Product Change Notification

PCN#: 459

Change Title: Packaging Specification Change

MODEL: FX135 Series

SMD 3.2x1.5mm Tuning Fork

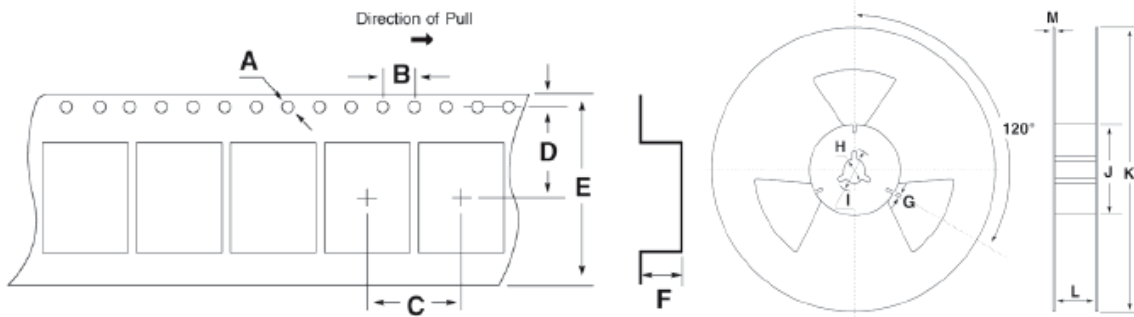
Change tape width from 8mm to 12mm.
Updated tape and reel specs on following page.

Reason for Change: To correct an error on the datasheet. Tape width has always been 12mm.

Tape Specifications (millimeters)							Reel Specifications (millimeters)						
A	B	C	D	E	F	Std Reel Qty	G	H	I	J	K	L	M
Φ1.5	4.0	4.0	5.5	12.0	1.0	3,000	2.0	Φ13	Φ21	Φ60	Φ180	13.0	1.2
